# Access Compliance Report

## Public Rights-of-Way

### (Pedestrian Signals)

Intersection ID: N/A	Main Street:	Cross Street: N/A	Location: N/A
ADA ID: 6C91B364D07E	Signal Type: One Push Button-Non APS	Overall Compliance: No	Severity Score: BTN 1: N/A BTN 2: N/A No BTN: N/A
Codes/Mitigation Info/Possible Solution		Field Measurements/Component Compliance

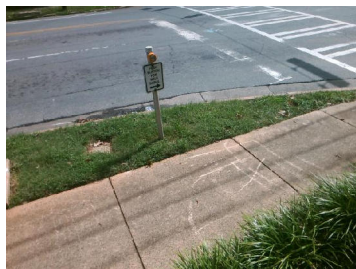
Possible Solutions: Remove & Replace Sign. Provide Push Button Extension. Provide Clear Space.

PROW/ADA: R410.6, R404.1, R404.7.3
